Work Order ID 107739

Item ID: D407-667-105

Item Name: Fwd Crosstube

| DRAWING NO.<br>D407-667-145 | TITLE<br>CROSSTUBE ASS'Y (407 HIGH FWD) | REV. C                  | <b>DART AEROSPACE LTD<br/>ENGINEERING ORDER</b> |  | D.E.O. NO.<br>D407-667-145-C-1 | SHEET NO.<br>SHEET 1 OF 1 | SCALE<br>NTS |

**DETAIL P**  
BONDING STRAP INSTALLATION 2 PL

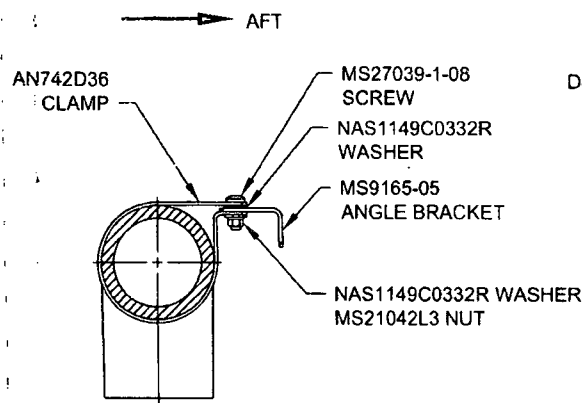
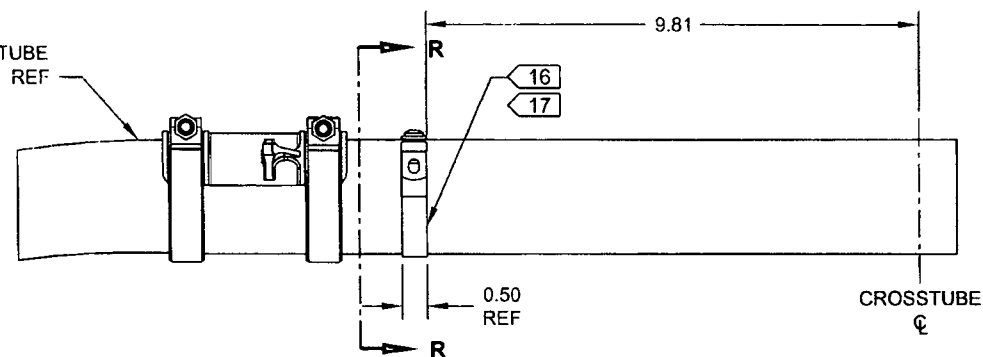
ADD ELECTRICAL GROUNDING STRAP

| ITEM | QTY<br>-145 | PART NUMBER   | DESCRIPTION                       |
|------|-------------|---------------|-----------------------------------|
| 13   | 2           | MS27039-1-08  | SCREW                             |
| 14   | 4           | NAS1149C0332R | WASHER (OR AN960C10L)             |
